TEN-T Priority Route Improvement Project, Donegal

Phase 2, Option Selection Report Volume C3 – Section 3 Non-Environmental Appendices

Appendix C3.6 – Section 3 Road Safety Audit Stage F – Part 2

Appendix C3.1 – Safety Assessment

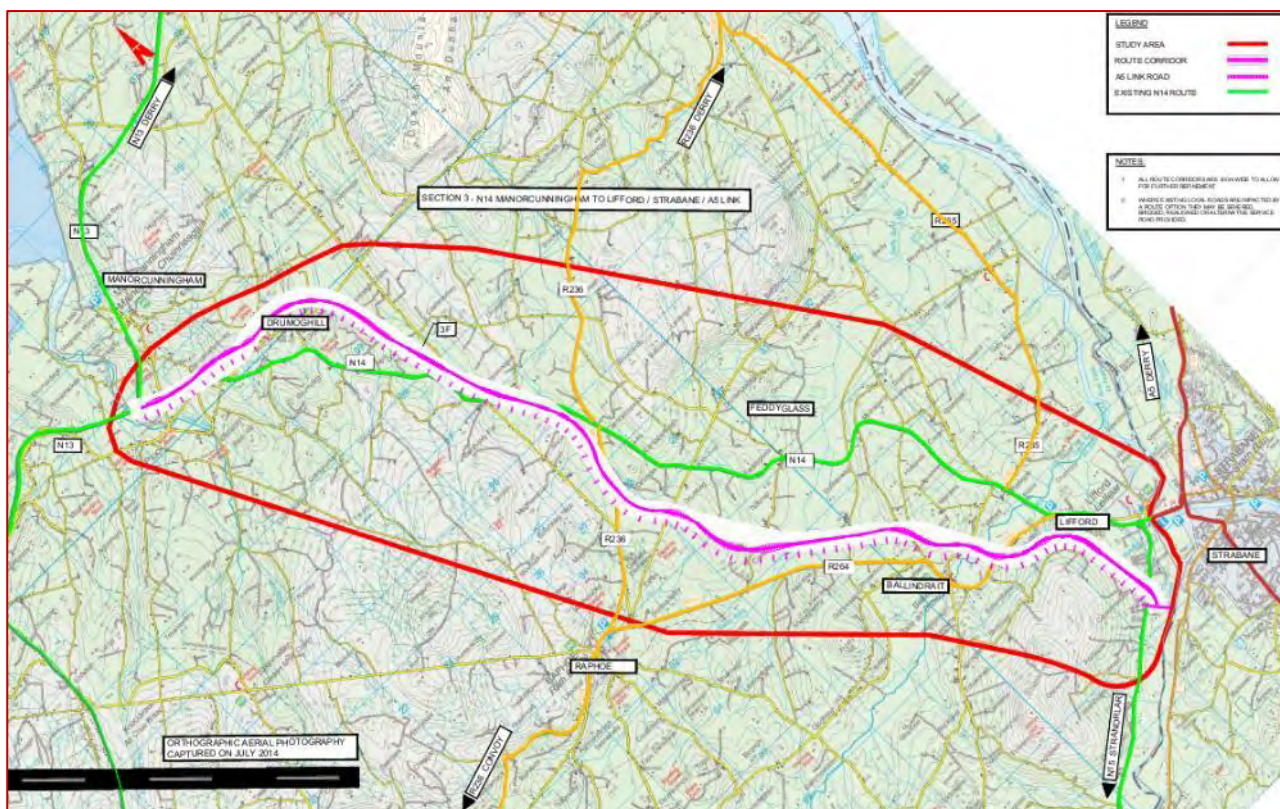
Problem

The proposed location of the junction between Option 3E and the existing R236 Regional Road could lead to increased traffic along the regional road, in particular to/from Raphoe. Should improvements to the regional road not be undertaken as part of the Scheme, this could result in increased collision occurrence and/or increased injury severity outcomes along the section of regional road between the mainline and Raphoe.

2.1 Problem

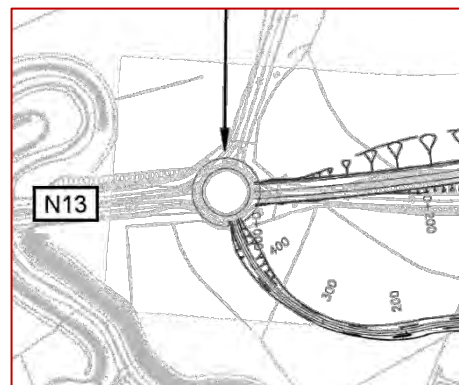
Location: Northern Tie-in at Pluck Roundabout

During the design development review the proposed junction type at this location in the context of the overall junction strategy for Sections 2 & 3 and ensure that the selected junction type can perform safely. Ensure all measures required to ensure the safe operation of the junction are included during the subsequent design development phases.

2.2 Problem

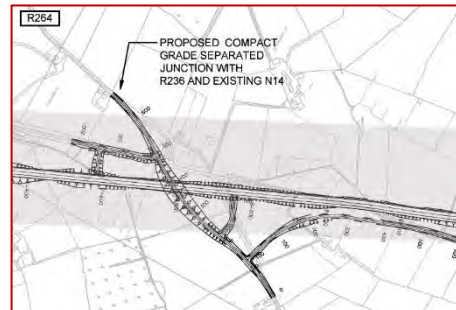
Location: Compact Grade-Separated Junction with Existing N14/R236

During the design development ensure adequate forward visibility for mainline drivers on the approaches to the proposed junctions. Ensure that safe diverging and merging manoeuvres can be undertaken (e.g. if necessary provide acceleration and deceleration lanes).

2.7 Problem

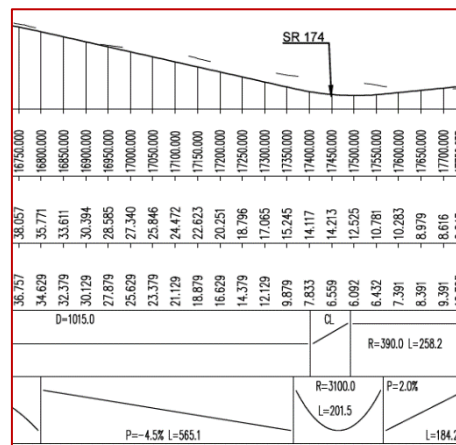
Location: Approach to Southern Terminal Roundabout

Summary: Loss of control collisions at relatively low-radius curve.

- Provide measures to ensure that drivers adequately moderate their speeds on the southbound approach to this curve; or
- Amend horizontal alignment to match the expected operational speeds at this location.

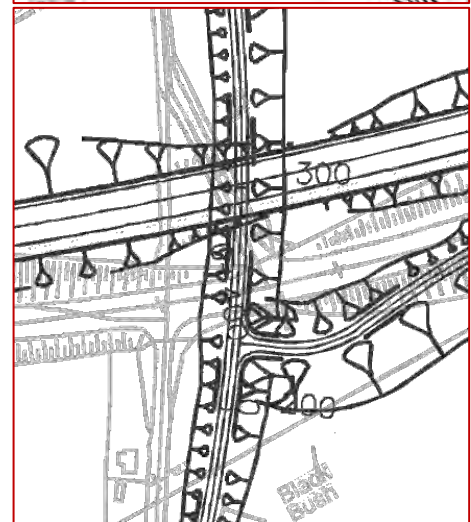
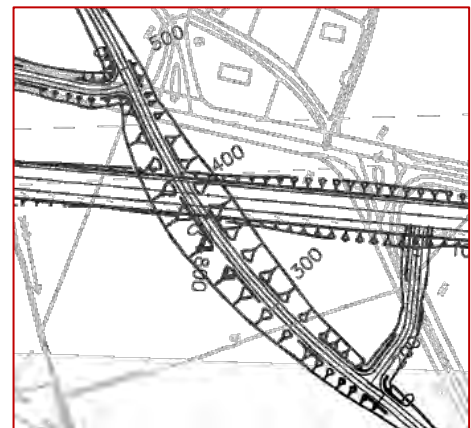
The realigned section of the existing N14, south of the proposed compact grade-separated junction between the mainline and the existing N14 and the R264 (approximate mainline chainages 8,100 to 8,600) runs close to the proposed mainline. There is a risk that during the hours of darkness that lights of vehicles on the realigned N14 could dazzle drivers on the mainline northbound carriageway resulting in them momentarily being unable to discern a hazard in the upcoming carriageway, and vice versa. This is exacerbated by the proximity of the diverge for the nearby junction.

Recommendation

During the design development provide anti-dazzle screening measures between the mainline and the side road at this location.
